C-17 LANDING-GEAR DURABILITY AND PARTS SUPPORT

Report No. 99-193

June 24, 1999

Office of the Inspector General
Department of Defense

Figure B-2. Aft Main Landing-Gear Test Schedule

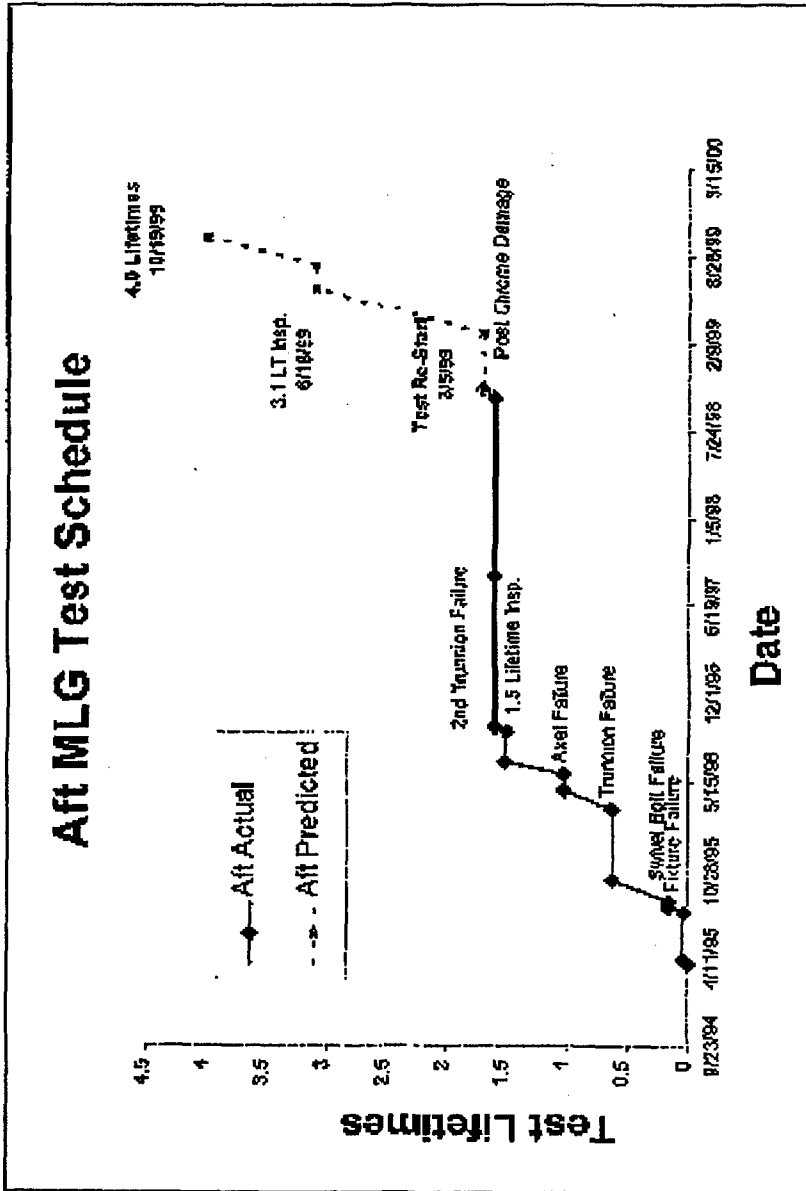
The results of durability tests on the nose and main landing gear components are shown in Appendix B. Appendix B, Figure B-2, shows that the aft main landing-gear trunnion collar initially failed at 0.63 lifetimes. After replacing that trunnion collar with a redesigned trunnion collar, durability testing resumed and the aft main landing gear trunnion collar failed again at 1.60 lifetimes. The trunnion design was redesigned and is undergoing durability testing. Appendix B, Figure B-3, shows that the forward main landing gear trunnion collar initially failed at 0.045 lifetimes. A redesigned trunnion collar was installed and reached 1.0 lifetimes of durability testing on October 21, 1998.

The aft main landing-gear trunnion collar failed at 0.63 lifetimes and was subsequently redesigned. The redesigned aft trunnion was installed in the test fixture, and testing resumed. The redesigned aft trunnion collar failed at 1.60 lifetimes. Accounting for the scatter factor of four, the failure corresponds to an actual life of 0.40. Testing of the aft landing gear was on hold for 2 years because of post redesign.

(4th paragraph, 3rd sentence) The trunnion collar that failed at 1.60 lifetimes was a redesigned trunnion collar, not an identical one. This fact is correctly stated in Appendix B.

Figure B-3. Forward Main Landing-Gear Test Schedule

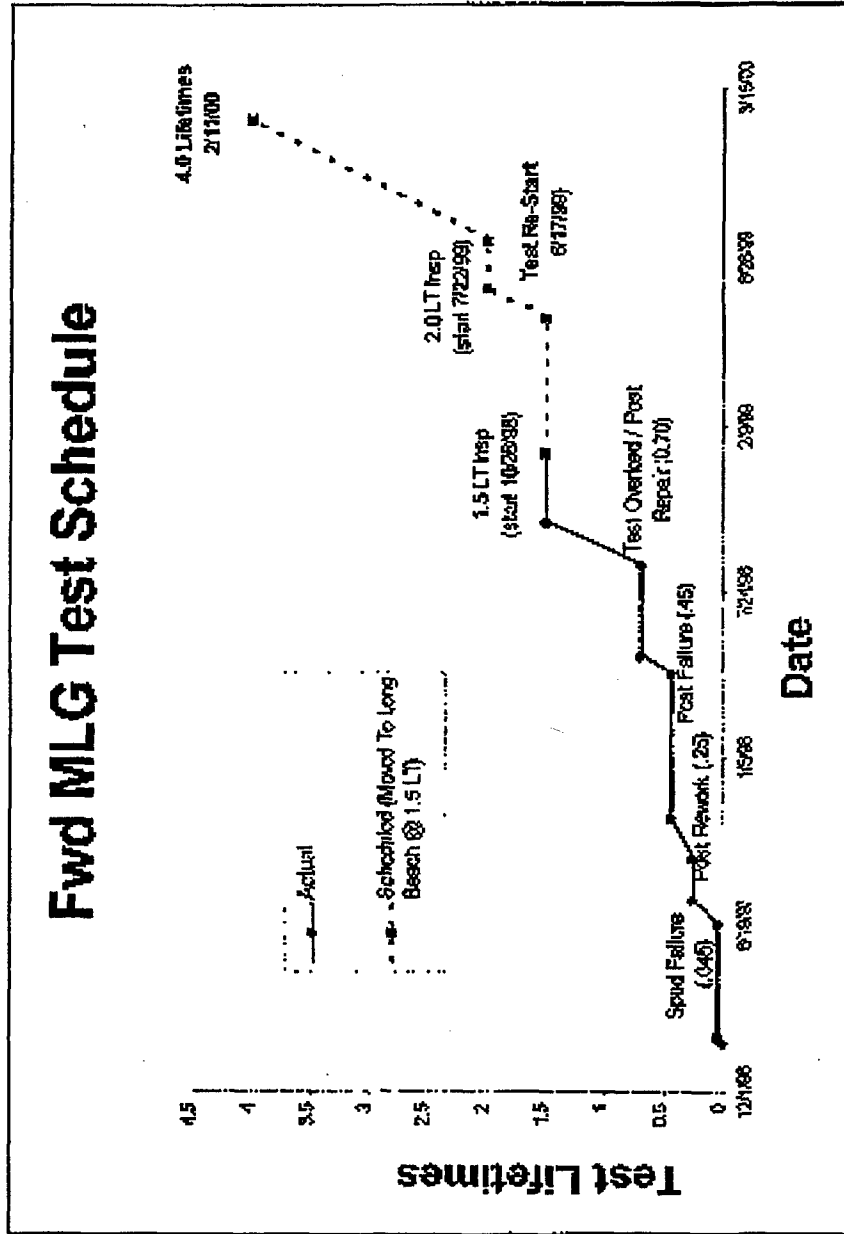
The forward main landing-gear trunnion failed at 0.045 lifetimes of test and was subsequently redesigned. The redesigned forward trunnion was installed in the test fixture, and testing resumed. Testing of the redesigned forward trunnion had reached 1.0 lifetimes in durability testing on October 21, 1998. Further testing of the forward trunnion will resume in the summer of 1999.

Figure B-4. Drawings of the C-17 Main Landing Gear

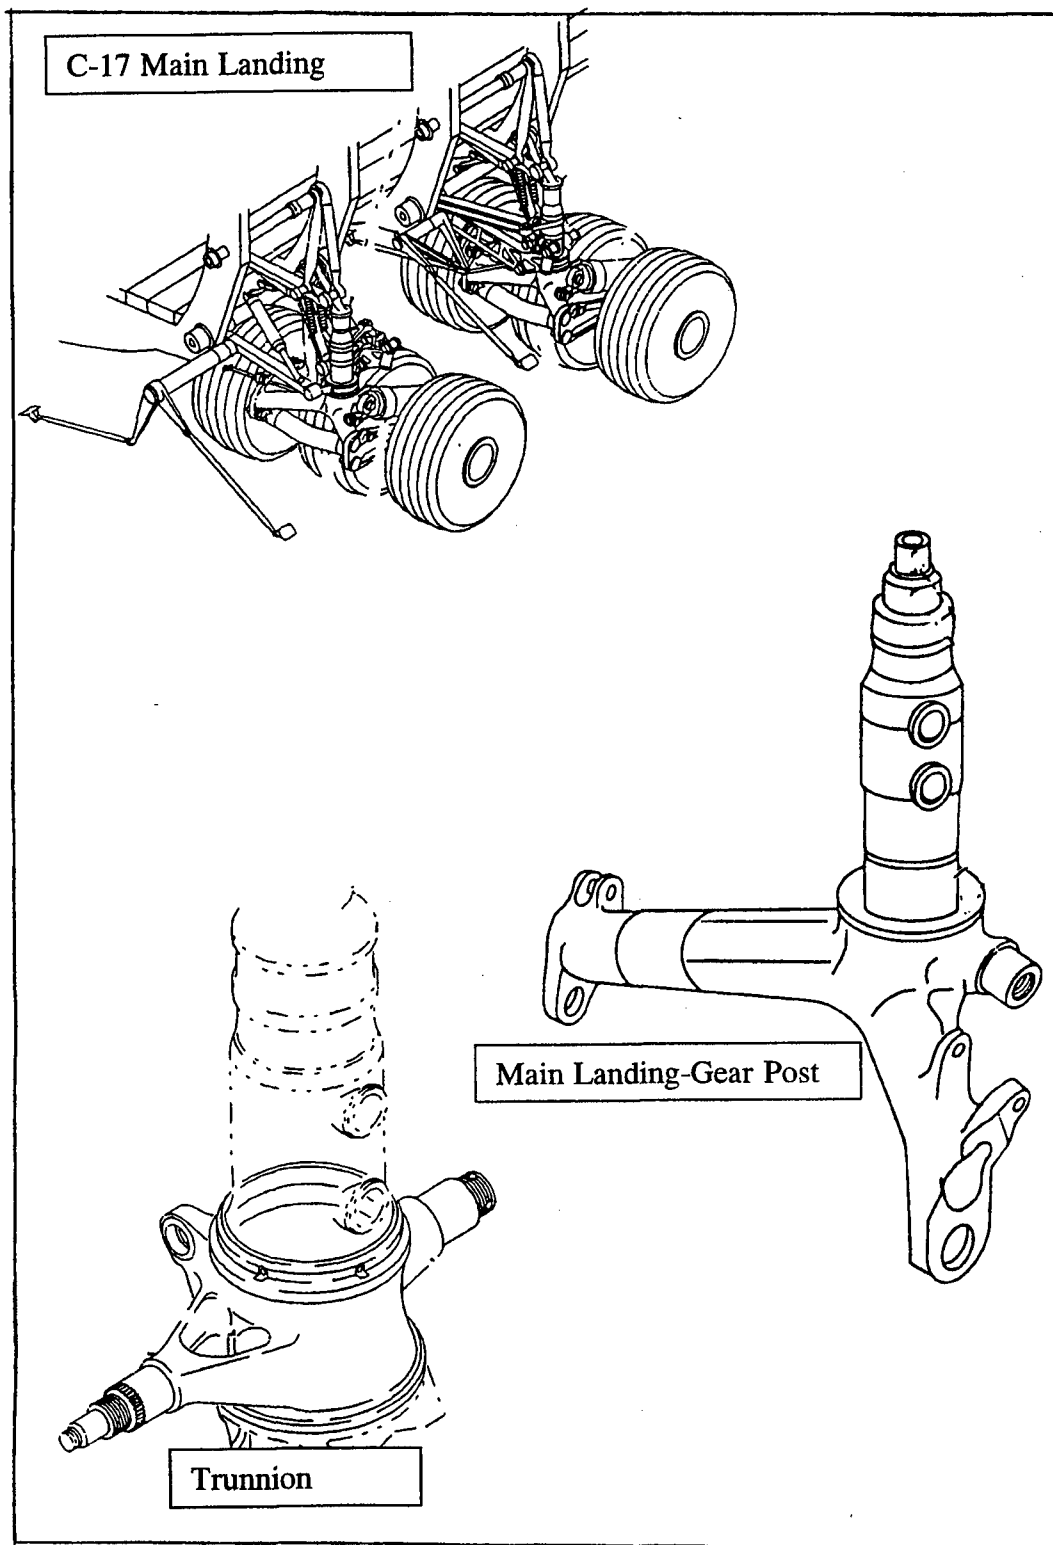
The forward and aft main landing-gear trunnion collars had repeated failures during durability testing, as shown in Figures B-2 and B-3. The trunnion collar and post are depicted in Figure B-4.

C-17 MLG BRAKES

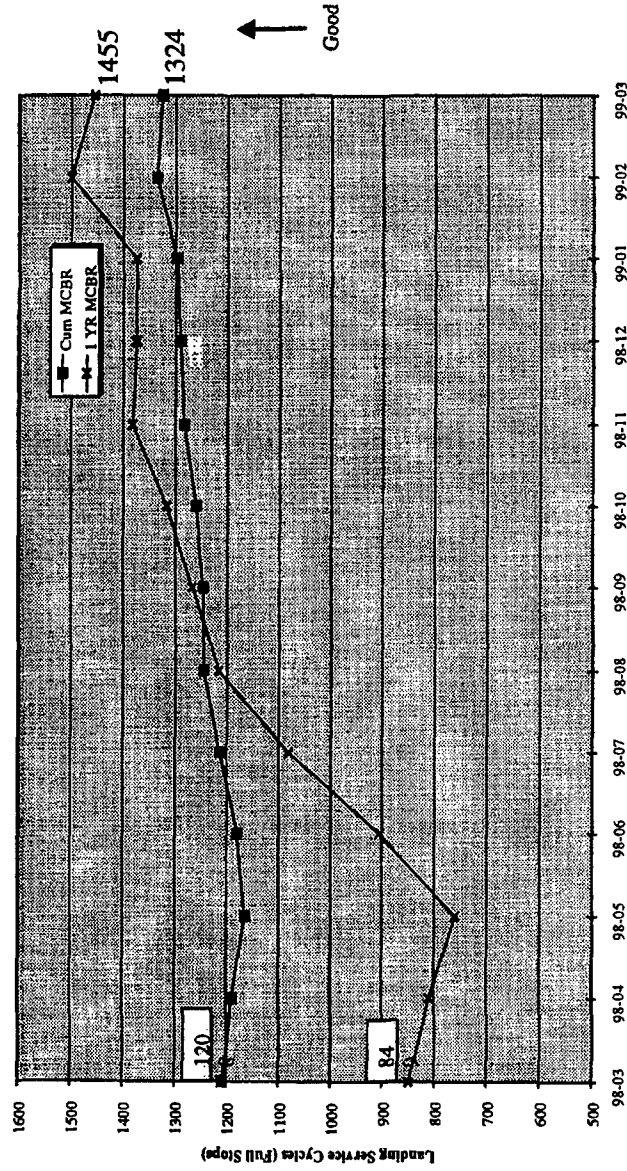
(1st sentence) Brakes are experiencing higher usage than identified in the Boeing procurement specification. However, the usage is in line with the Air Vehicle Specification, which is our baseline for weapon system performance.

Recommendation 3: The process of investigating costs and benefits of a new brake design has already begun. The contractor has received proposals for new brake designs from its vendors.
